SECTION 009113 – ADDENDUM ONE

- A. Project Name: Alliance Fire Station
- B. Owner: Madison County
- C. Architect: Dale Partners Architects, PA
- D. Architect Project Number: 22019
- E. Date of Addendum One: 26 October 2022

22019 Alliance Fire Station / Pre-Bid Meeting

3 FIXTURE 'SA' MOUNTING DETAIL
 Scale: NONE

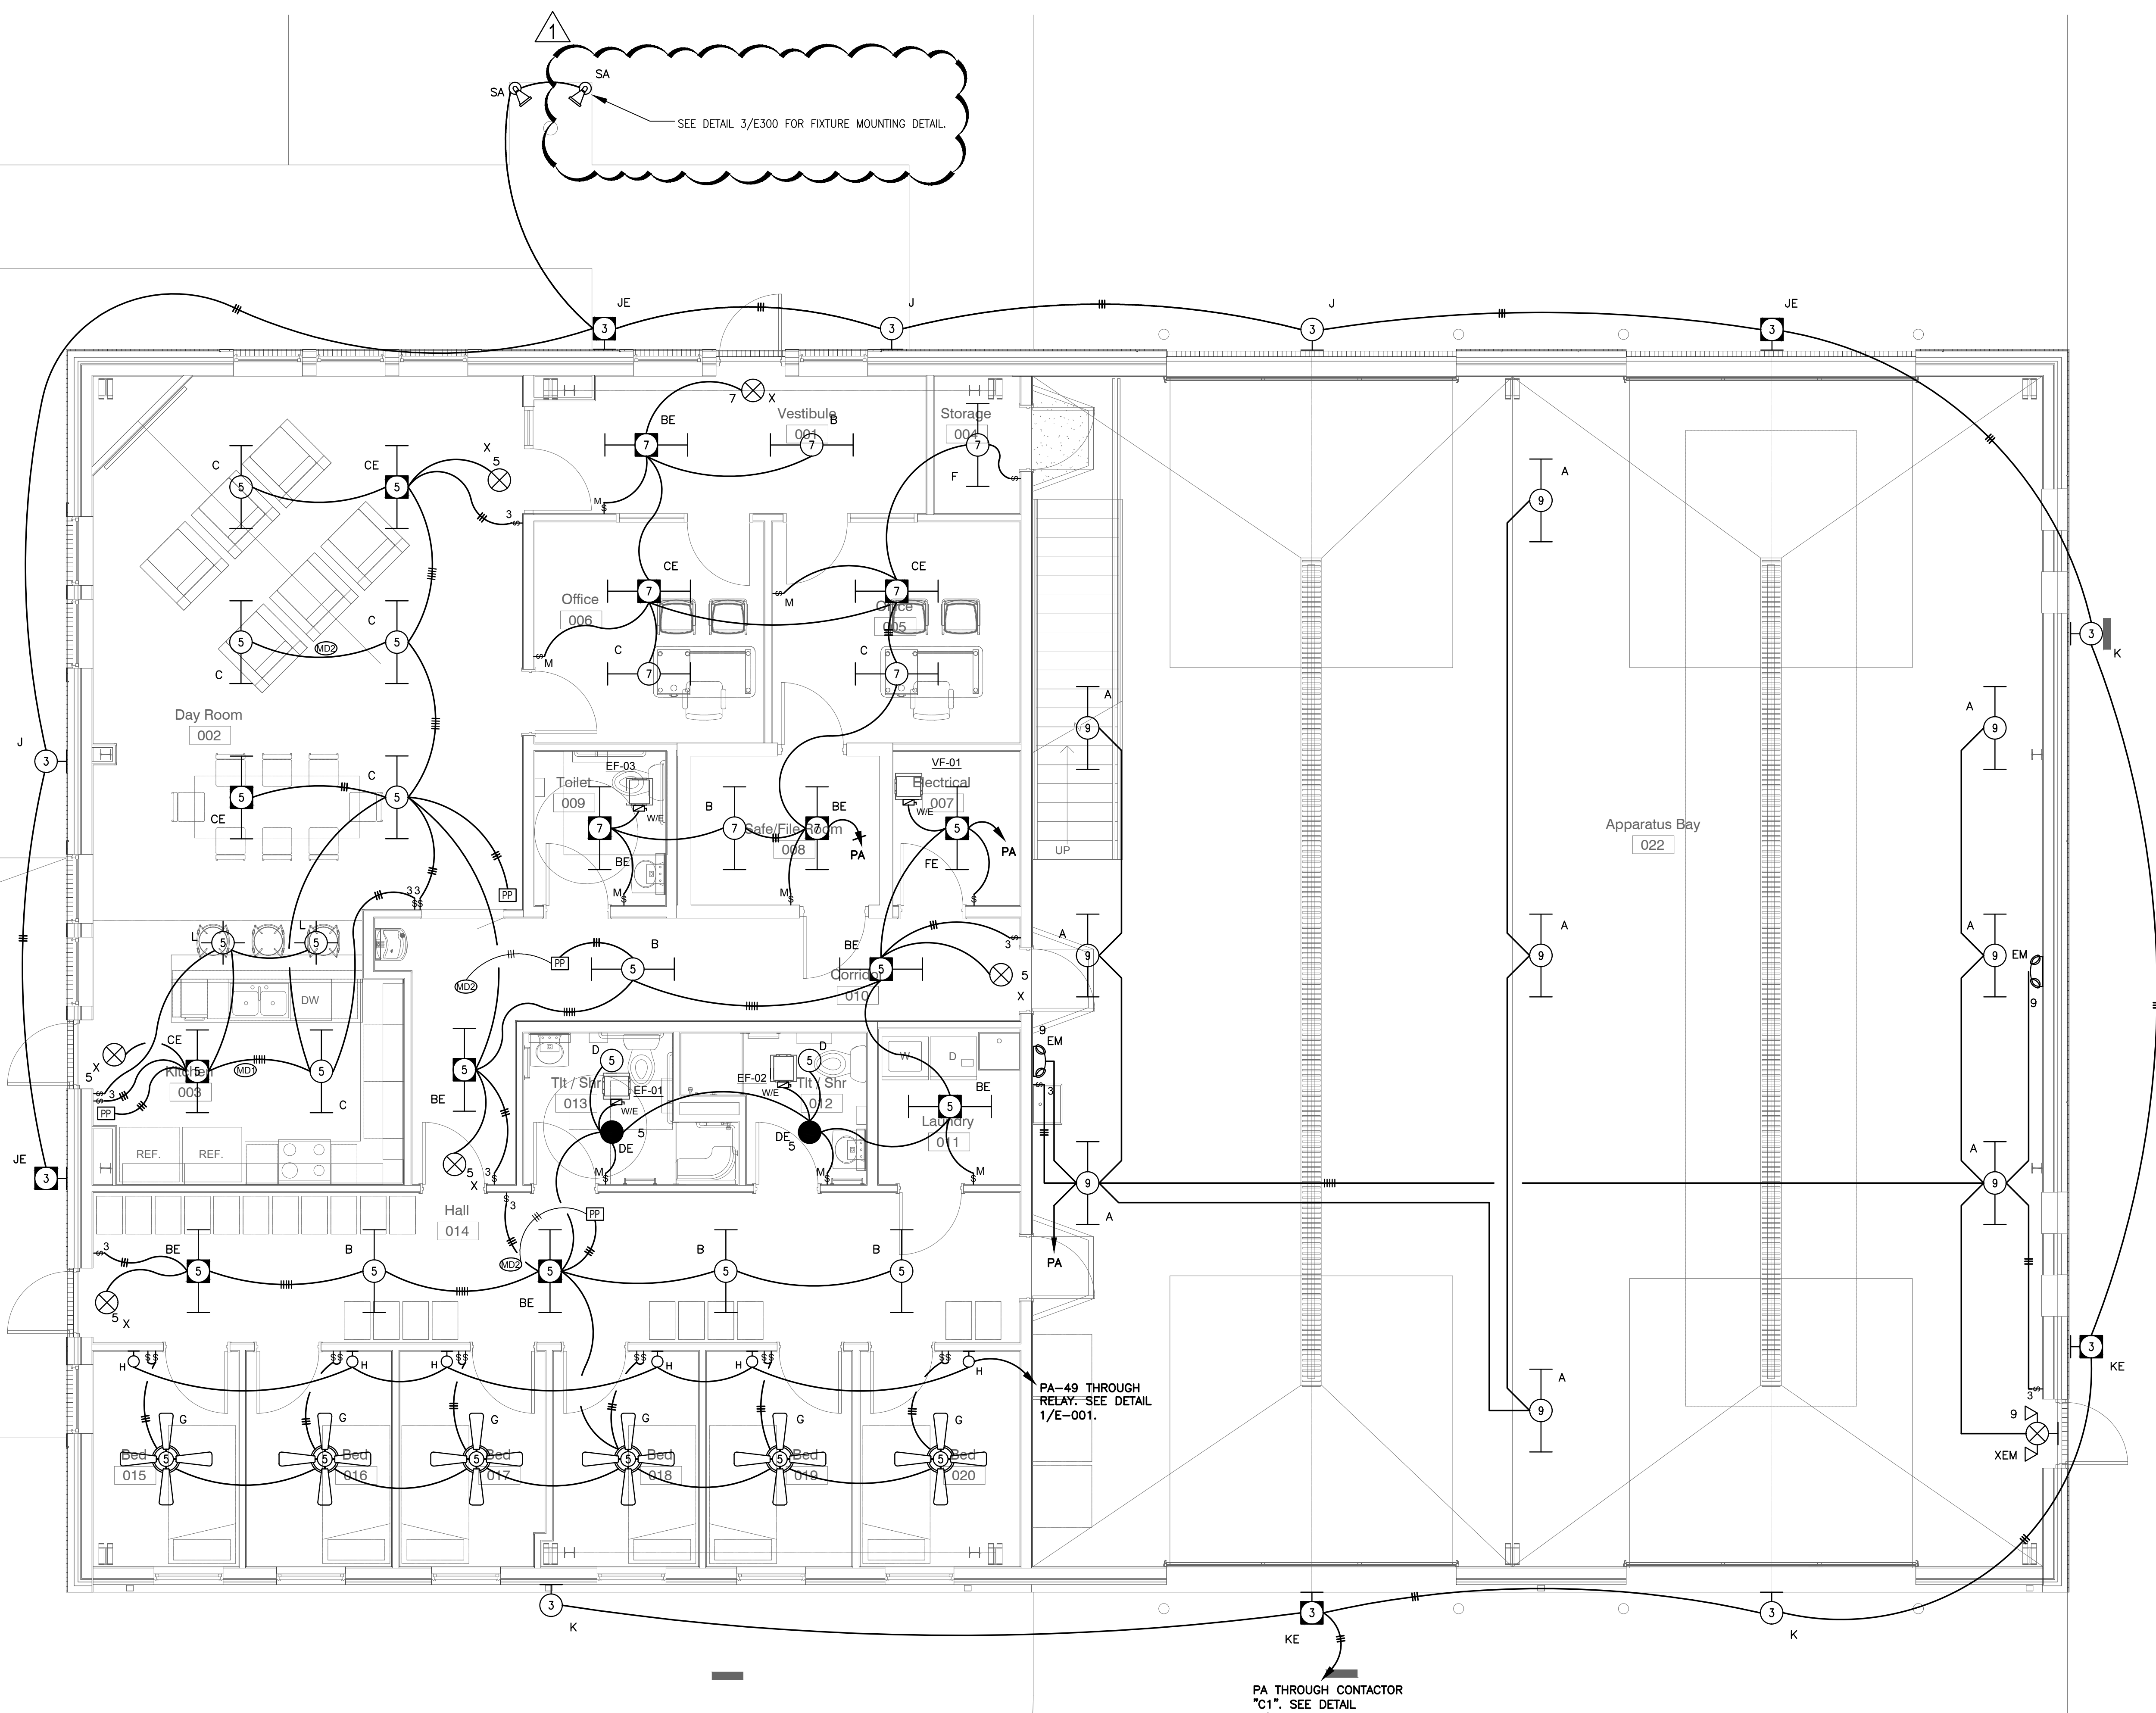
- Answer: The wording on this alternate was reversed. Please provide CMU walls instead of stud walls as the scope for this alternate.
- F. Question: There is a SA light on the plans but nothing on the fixture schedule, can we get clarification on what type of light this needs to be?

- A. Electrical Sheet E000 – ELECTRICAL LEGEND. Delete the sheet in its entirety and replace with the attached. Added flagpole fixture (SA) to the light fixture schedule and the mounting detail for that fixture. Also added the lighting contractor detail to the drawings.
- B. Electrical Sheet E300 – LIGHTING PLAN FIRST FLOOR. Delete the sheet in its entirety and replace with the attached. Added flagpole fixture (SA) to the light fixture schedule and the mounting detail for that fixture. Also added the lighting contractor detail to the drawings
